# UNITED STATES PATENT AND TRADEMARK OFFICE

APPLICATION NO.	FILING DATE	FIRST NAMED INVENTOR	ATTORNEY DOCKET NO.	CONFIRMATION NO.
10/777,579	02/12/2004	George Jordan	JORDAN01	6001

**Office Action Summary**

## DETAILED ACTION

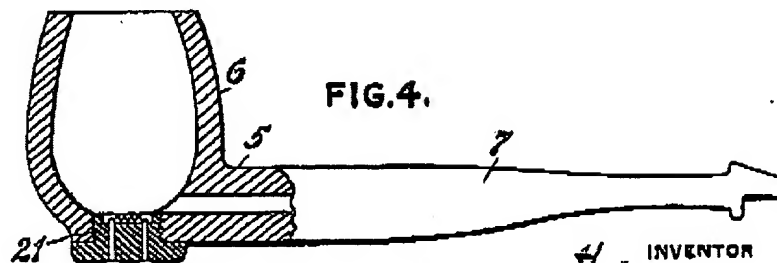
Regarding applicant claim 1, Fulton discloses a smoking device comprising a combustion chamber bowl (figure 4, element 6) for containing combustible materials to be burned and a mouthpiece pipe (5) communicating with the combustion chamber. Although Fulton discloses an

ignition means below the bowl (element 21 or column 1, line 51-55) he does not disclose a piezoelectric ignition device.

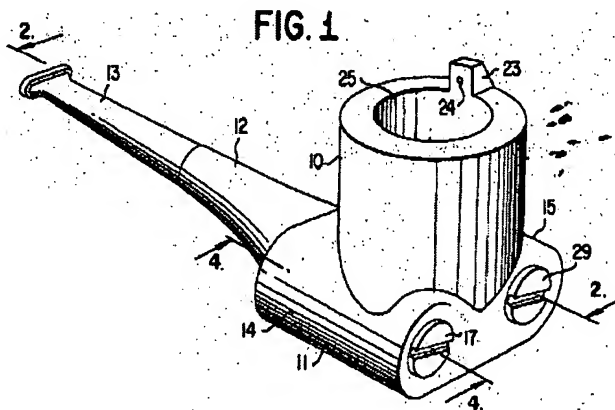
Tucker discloses a piezoelectric ignition device as part of a smoking device (column 4, lines 9-15). Although Tucker employs the same type of device to start ignition as the instant application, Tucker's piezoelectric ignition system is located at the top of combustion chamber (figure 1, element 24).

Regarding applicant claim 5, Tucker discloses a piezoelectric ignition device that includes a fuel tank for gaseous fuel (column 3, lines 8-18). Located behind element 29 in figure 1 above.

Regarding applicant claim 7, Tucker discloses a removable cover for the fuel tank (column 3, line 11-15, and element 29 in figure 1).
